Council assessment of Clause 4.6 request

The applicant has lodged a Clause 4.6 variation request to vary the 64 m height control under Clause 4.3 Height of Buildings in Blacktown Local Environmental Plan 2015. Upon initial review of the variation request, the objectives of Clause 4.3 Height of Buildings development standard were not adequately addressed, and sufficient environmental planning grounds were not provided to justify the contravention to the development standard. An amended Clause 4.6 variation request was requested from the Applicant, by way of a request for additional information from Council, to properly address the objectives of the standard. A copy of the applicant's amended Clause 4.6 submission dated November 2022 is at attachment 6.

Figure 1: Height Plane Diagram from Architectural Drawings depicting the extent of non-compliance of the height of 64m for the building

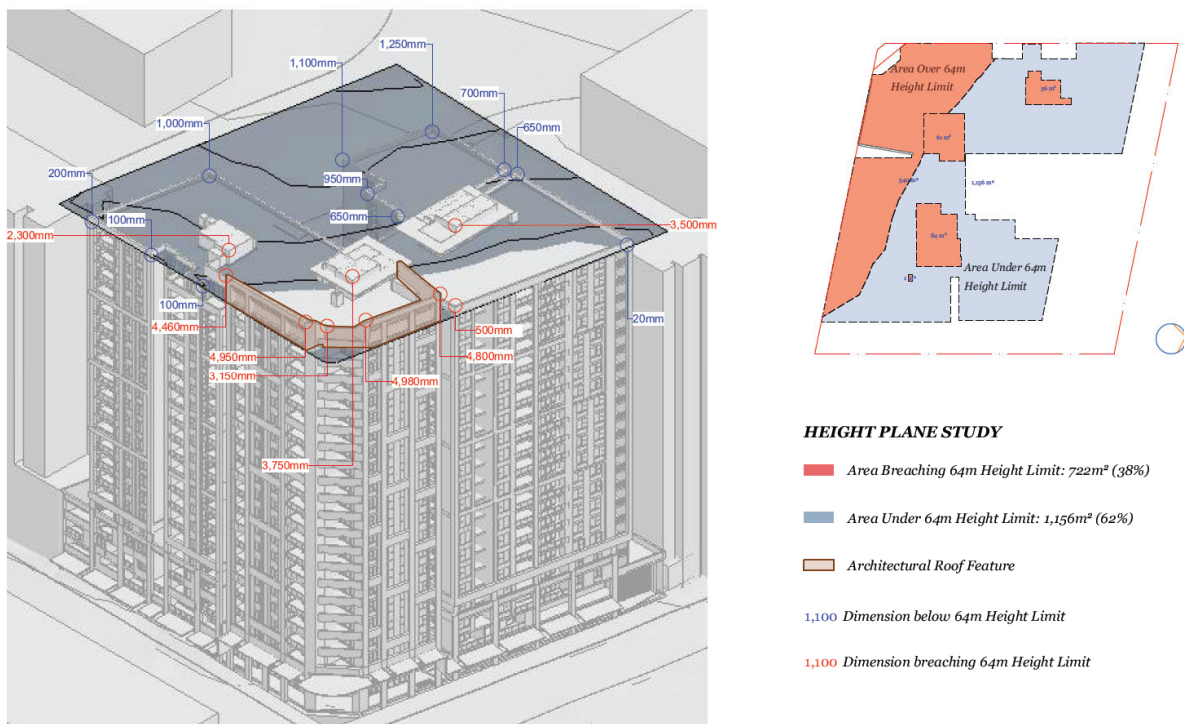
The following building height plane identified the portions of the development that exceed the 64m height limit.

The variations to the building height control are considered minor as a portion of the overall building height as detailed in the building height plane diagram in Figure 1 above.

- The proposed variations relate to an architectural roof feature, lift overruns and small sections of the roof parapet which forms a planter bed to the edge of the rooftop open space. The points of variation are considered minor in nature as they are discrete and essential elements of the rooftop

The applicant's Clause 4.6 request and the revised plans provide satisfactory evidence that the proposal has demonstrated justifiable grounds for the minor variations to the numeric height control in this case.
